ITEM 68A/68B

20-2003-5.54 713 20th Street
Paul Mangan Replace several
windows with vinyl, reroof two
front porches and dwelling

CITY OF DES MOINES HISTORIC PRESERVATION COMMISSION
STAFF REPORT AND RECOMMENDATION
Wednesday, July 20, 2016

Requested Action: Replacement of 4 windows on the south façade of the building.

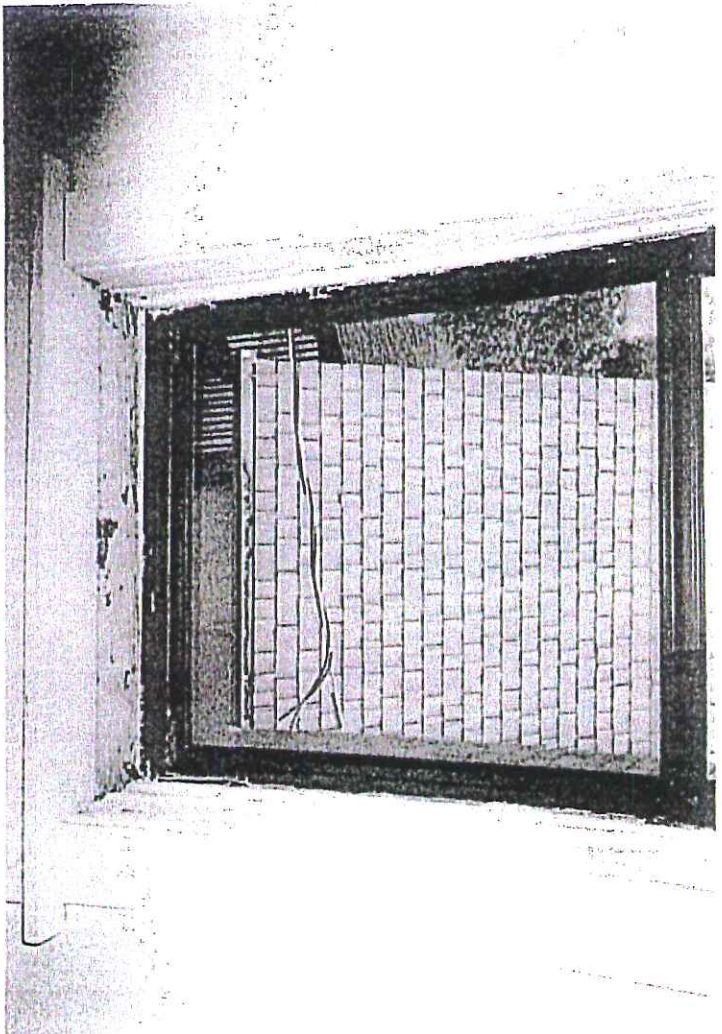
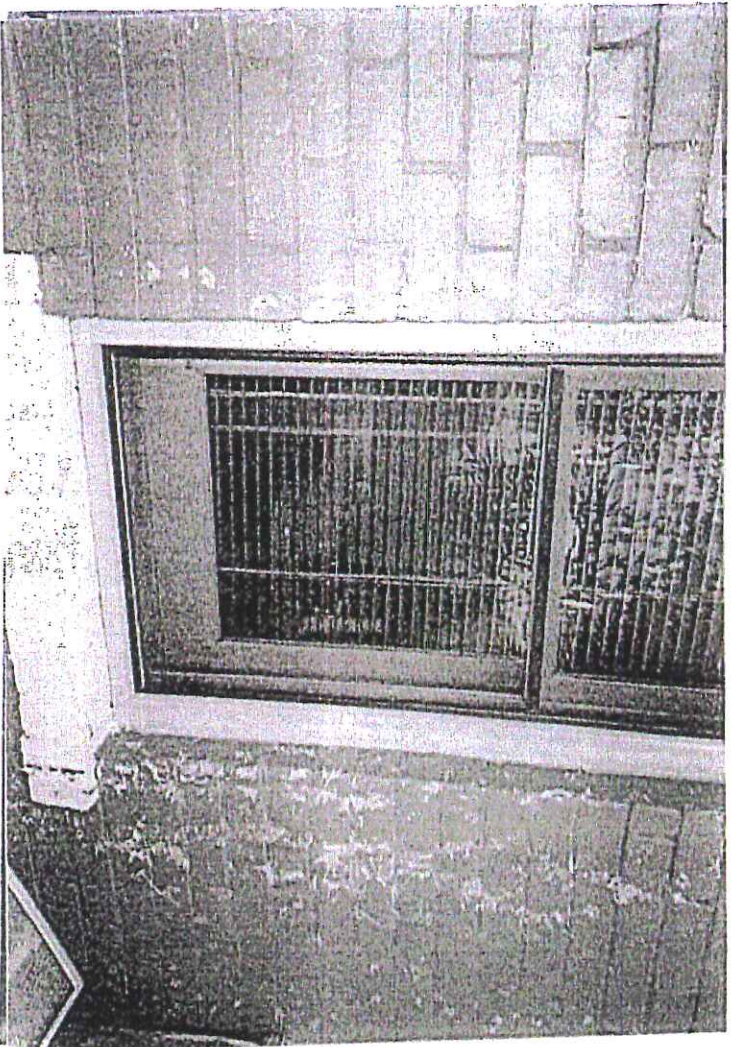
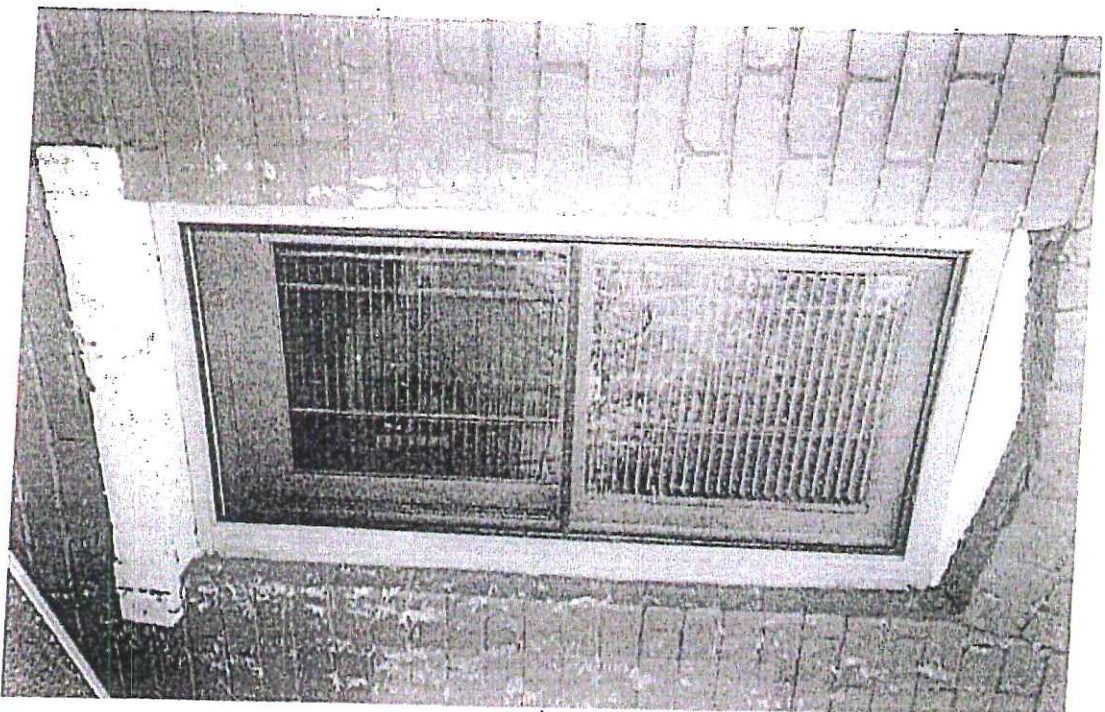
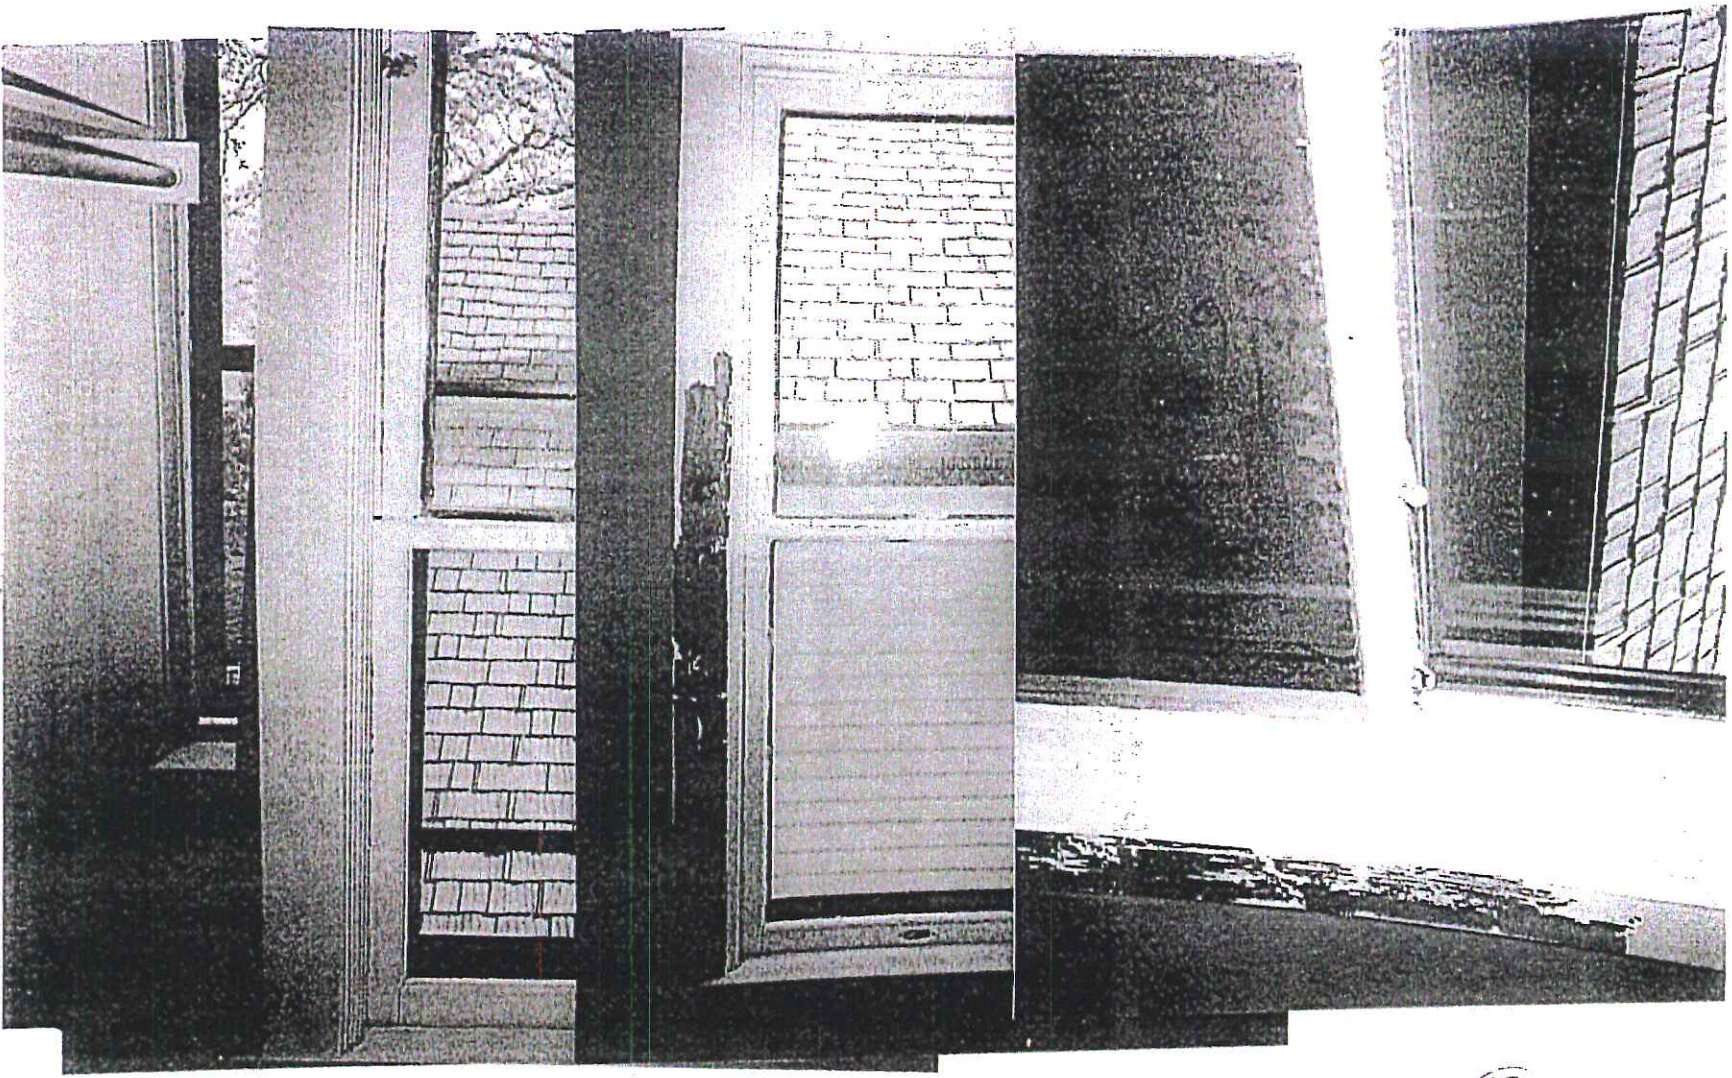
- ① No window here, just frame window, needs new window
- ② Existing 'Good' window that is used. Frame vinyl casement
- ③ Another 'Good' window that is painted outside for ease
- ④ 'Bad' window that needs to be replaced, nothng stills

- ① No window here, just storm window, needs new window
- ② Existing 'Good' window that is wood frame vinyl casement
- ③ Another 'Good' window that is painted outside frame
- ④ 'Bad' window that needs to be replaced, rotten sills

826 18th St Window Report/Conlin Properties

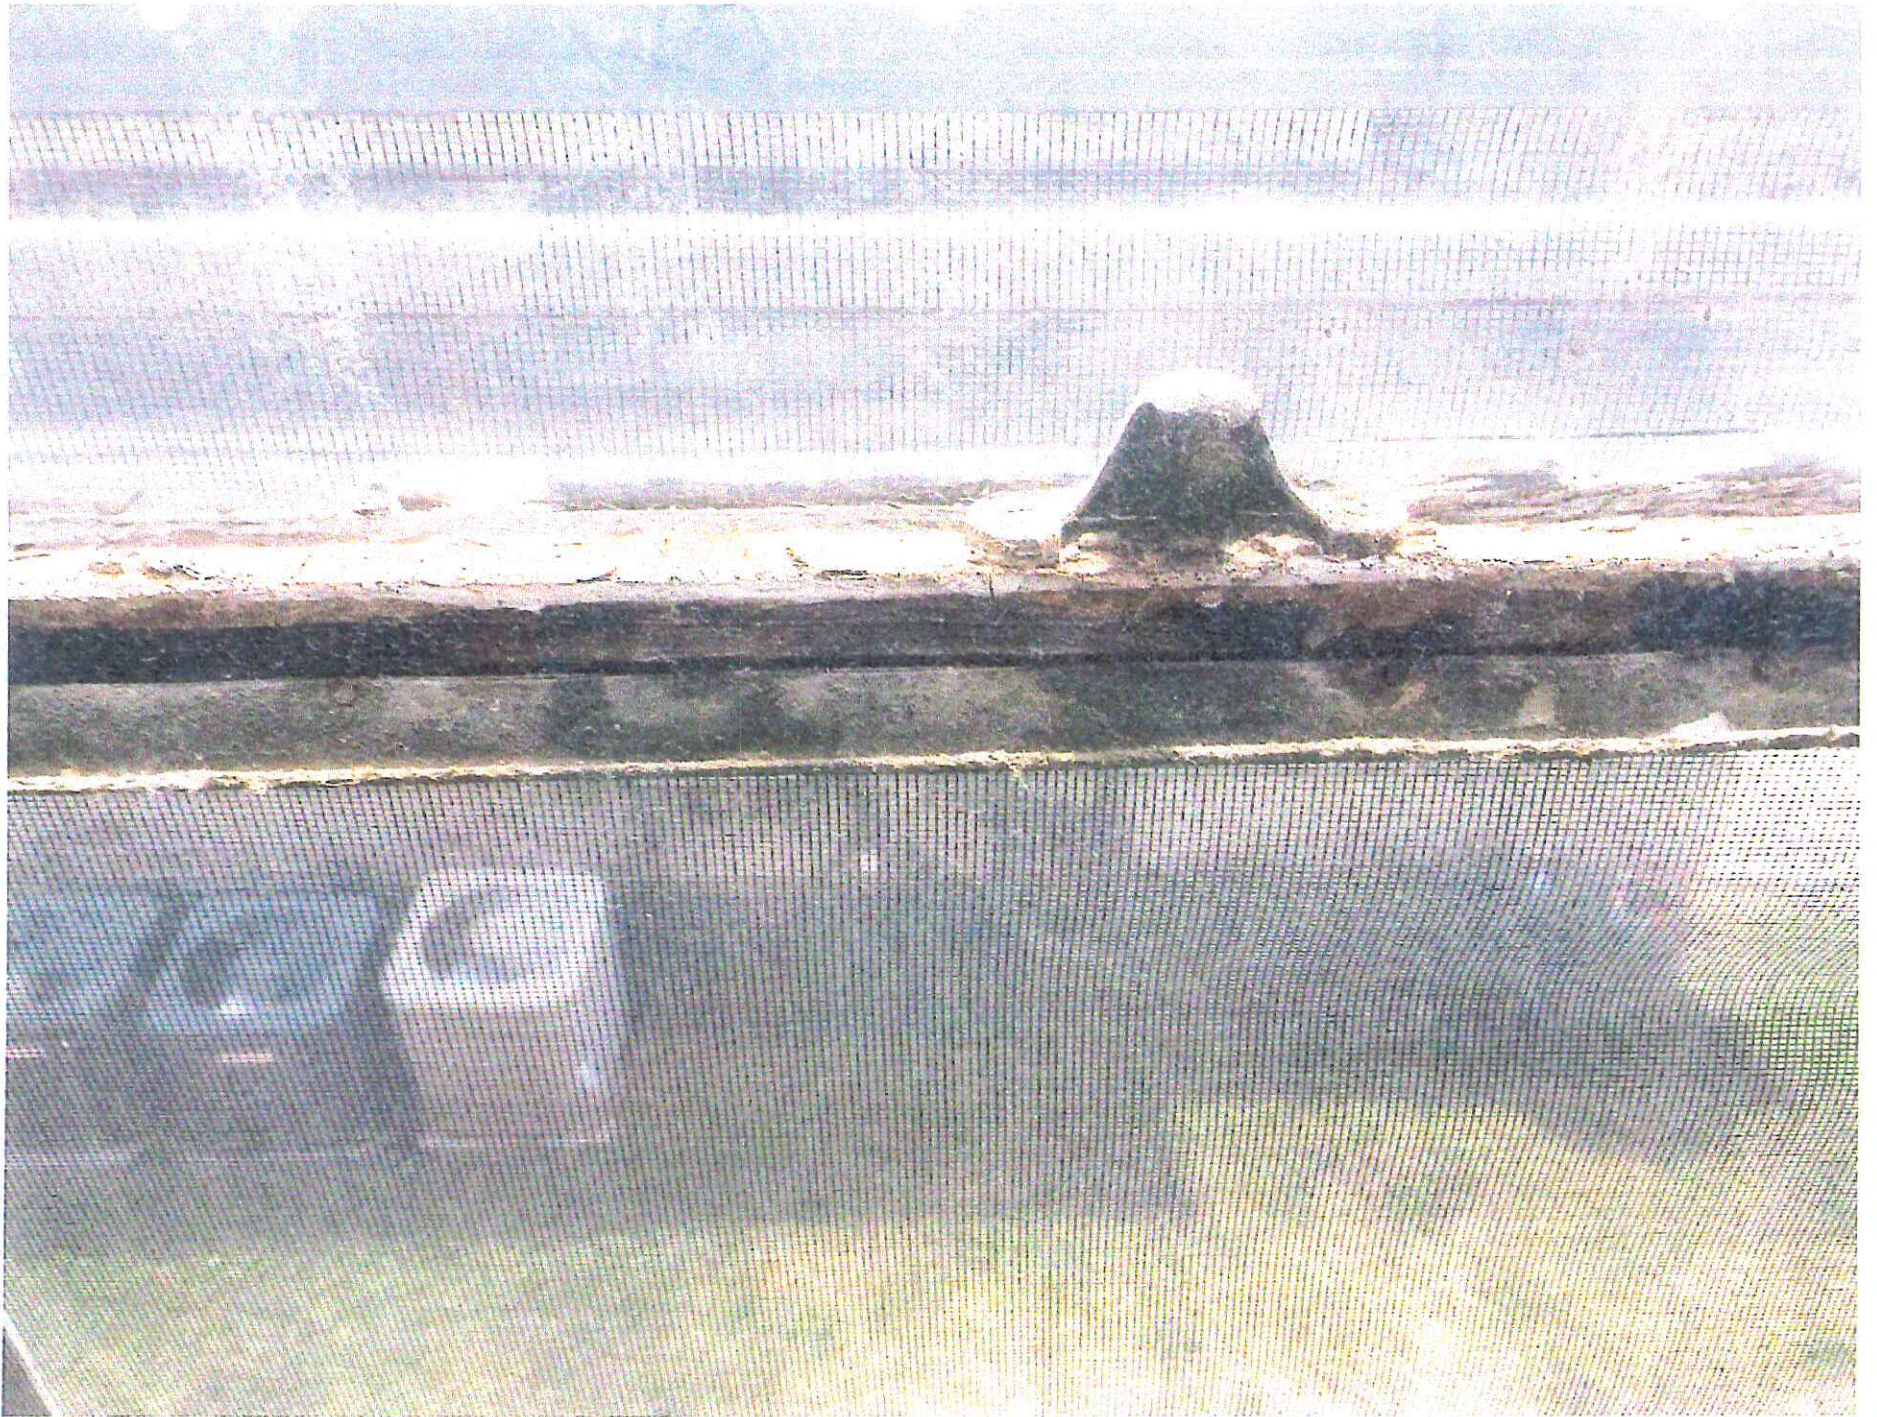
On 6-22-16 I was asked to assess the possibility of replacing two windows on the south elevation of the property at 826 18th St in Des Moines for Conlin Properties. The property is in an historic district and the preferred procedure would be to repair existing materials when possible. After a thorough inspection of the windows in question, it is my determination that repair of the existing window units is no longer possible. Both windows, jambs and sashes included, show extreme rotting and signs of prior repairs that have sustained them up to this point but are no longer able to provide a functioning window unit(s).

One of the two has at some point had jamb stops removed and aluminum sash slides installed so that it can no longer be considered original.

Rotten sill

Rotten Condition

Can place finger through window sill

Rotten sash

More wood rot
